A585 Windy Harbour to Skippool Improvement Scheme

7.11 Environmental Statement Changes and Corrections Document

Environmental Statement Changes and Corrections Document

Regulation Number:	Regulation 5(2)(q)
Planning Inspectorate Scheme Reference	TR010035
Application Document Reference	TR010035/APP/7.11
Author:	A585 Windy Harbour to Skippool Improvement Scheme Project Team, Highways England

Client
Project A585 WINDY HARBOUR TO SKIPPOOL IMPROVEMENT SCHEME
Drawing Title ENVIRONMENTAL STATEMENT REGULATION 5(2)(a) ROAD DRAINAGE AND WATER ENVIRONMENT: A□IFERS

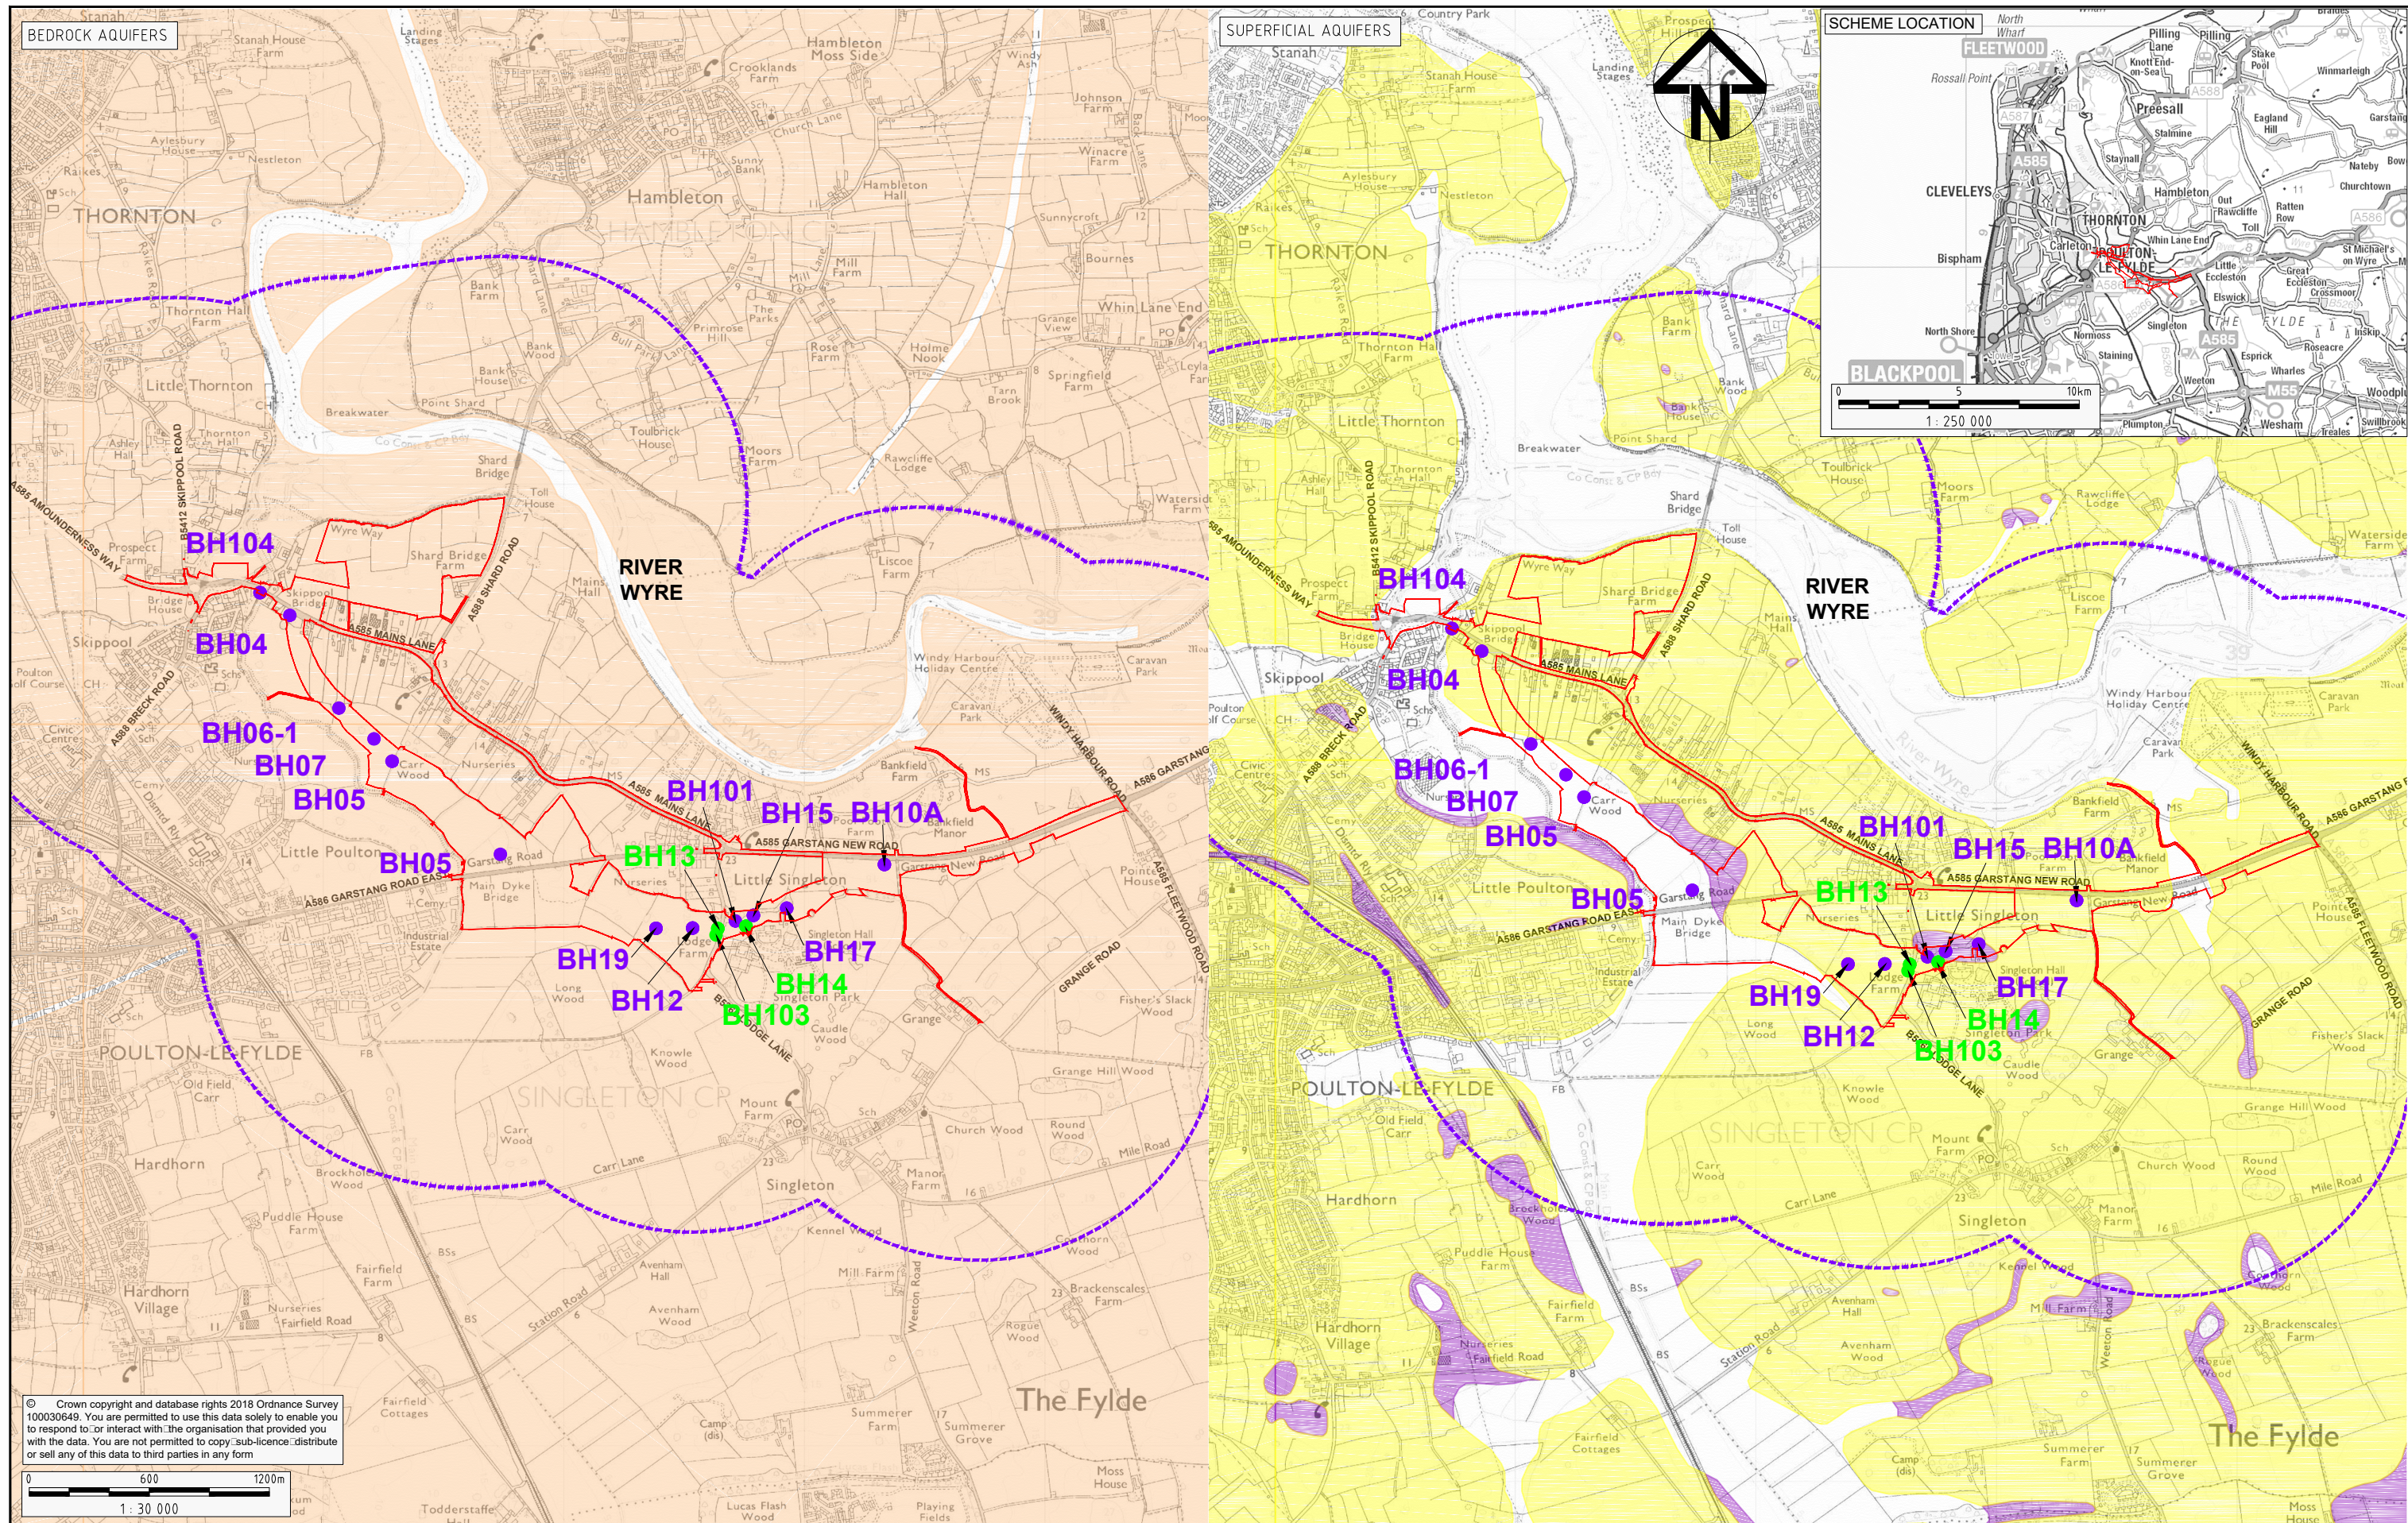
6.12	ES Chapter 12: Road Drainage and the Water Environment	Updated Figure 12.2: Road Drainage and The Water Environment – Aquifers provided at Appendix F to show locations of manual and automated readings for groundwater investigations.	Requested by the Inspector within the first round of written questions (document reference TR010035/APP/7.10).
